Memorandum

SUBJECT: CALCULATION OF THE BLOWDOWN PRESSURE PEAK FOR THE INDIAN POINT II
CONTAINMENT CONSIDERING THE STORED COOLANT ENERGY, THE INTERNAL CORE
ENERGY, THE ENERGY ASSOCIATED WITH THE POSITIVE MODERATOR COEFFICIENT
AND THE SECONDARY COOLANT FROM THE RUPTURE OF ONE STEAM GENERATOR

50-247

Fig. 1

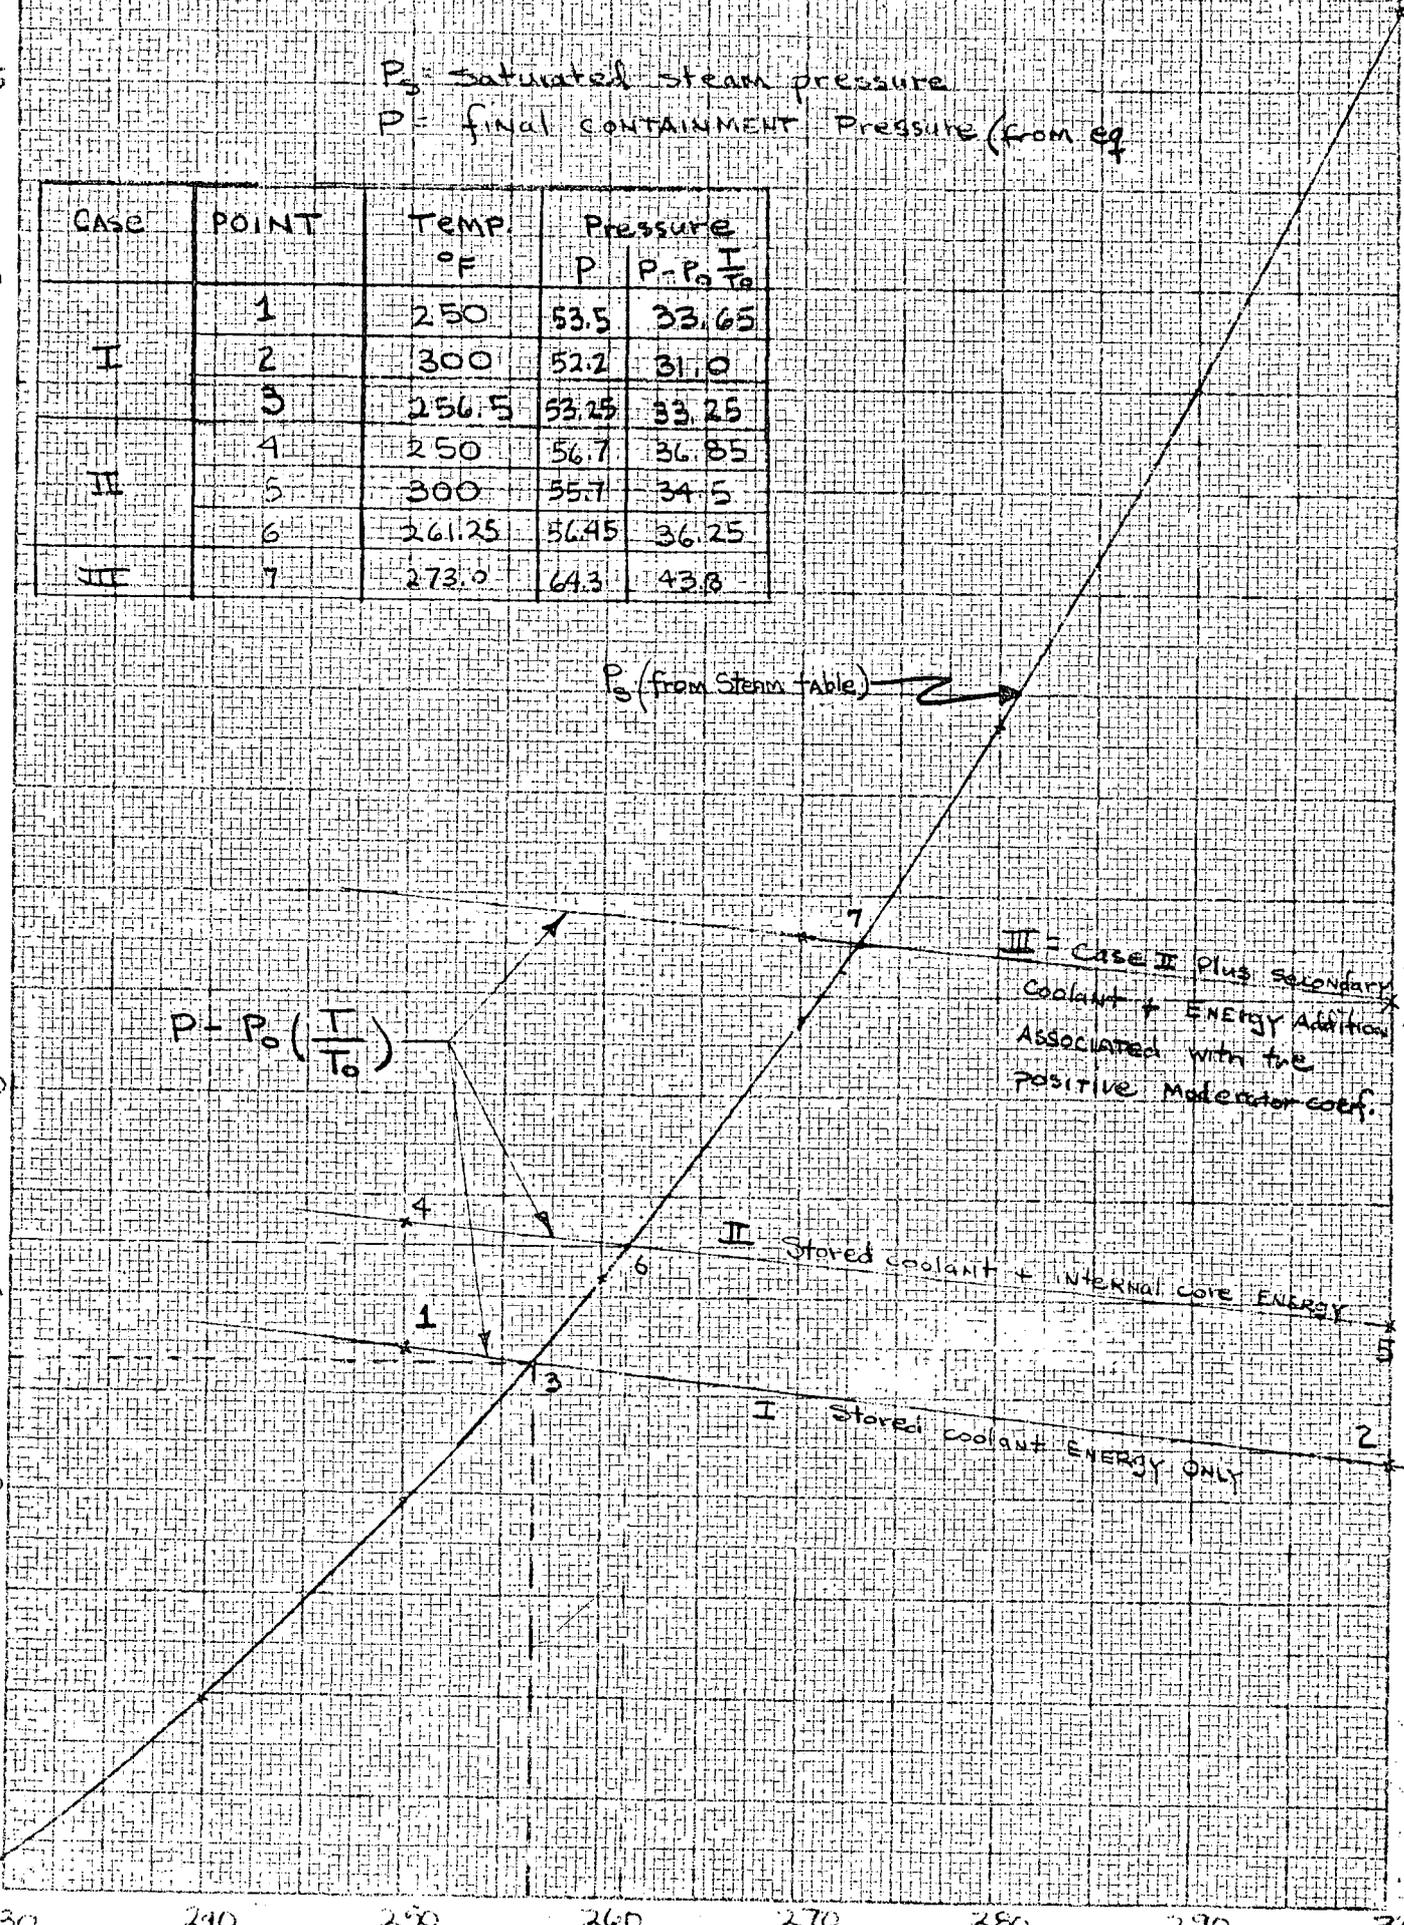
By assuming a temperature in the containment "T" and finding the associated h_{fg} , one can calculate the resulting pressure by the use of equation (3). This pressure varies slowly with temperature therefore by finding only two values of P(T) the saturation steam pressure in the containment can be found. The attached figure is a plot of saturated steam pressure as of function of temperature. The intersection of the P_s curve and the $P - P_o \frac{T}{T_o}$ line obtained from equation (3) gives the pressure and temperature of the steam in the containment.

From equation (3) (considering only the stored primary coolant energy) the pressure "P" is 53.5 psia at 250°F and 52.2 psia at 300°F. The intersection of the line joining the partial pressure due to steam ($P - P_o \frac{T}{T_o}$) at these temperatures crosses the saturation pressure curve at T_o 33.25 psi which corresponds to a temperature of 256.5°F. From these values the absolute pressure in the containment is:

The gage pressure therefore is 38.55 psig which is "exactly" the value presented in Fig. 12.1 of the Preliminary Safety Analysis Report (PSAR). This pressure is due to the stored coolant energy only.

Fig. 2

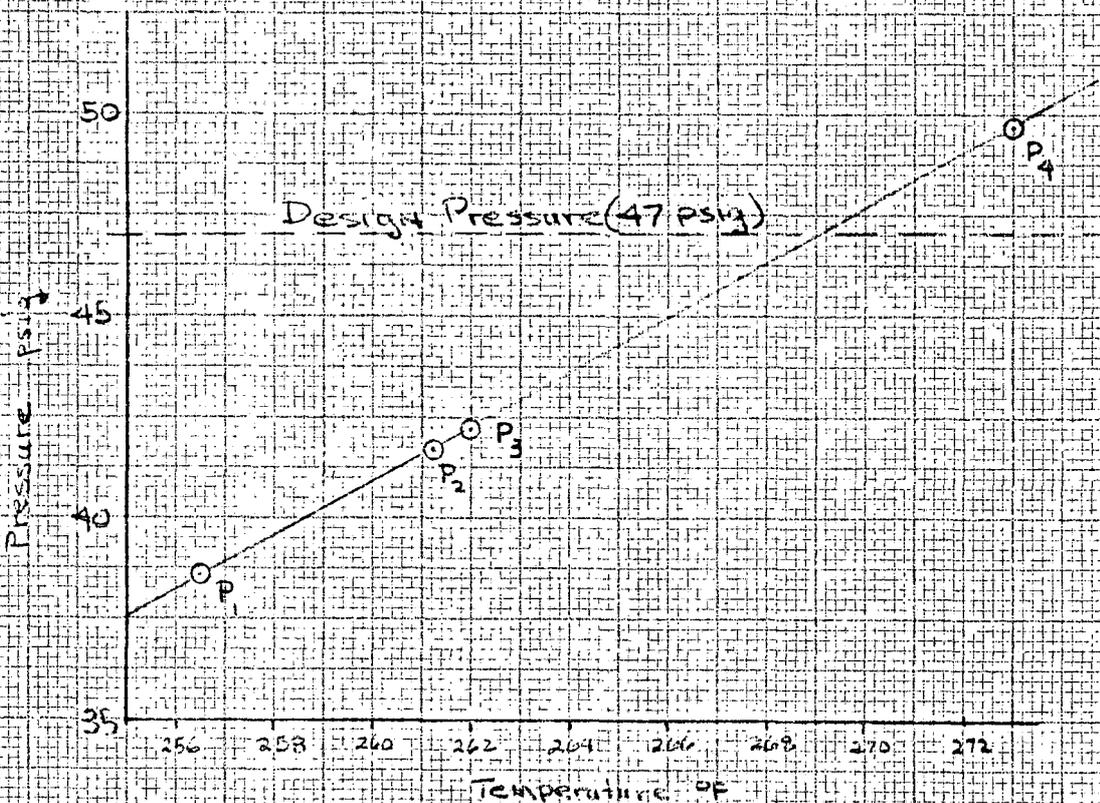
If one were also to consider the energy addition due to a rupture of one of the steam generators, there would be a considerable increase in containment pressure. Considering the secondary volume to be 2400 Ft.³ at the operating conditions the energy available is 61.8×10^6 BTU's and the containment pressure could increase an additional 7.4 psi. (See attached figures)

A significant increase in pressure will result if there is a rupture in one of the steam generators. If this should occur they would exceed the containment design pressure during the blowdown phase.
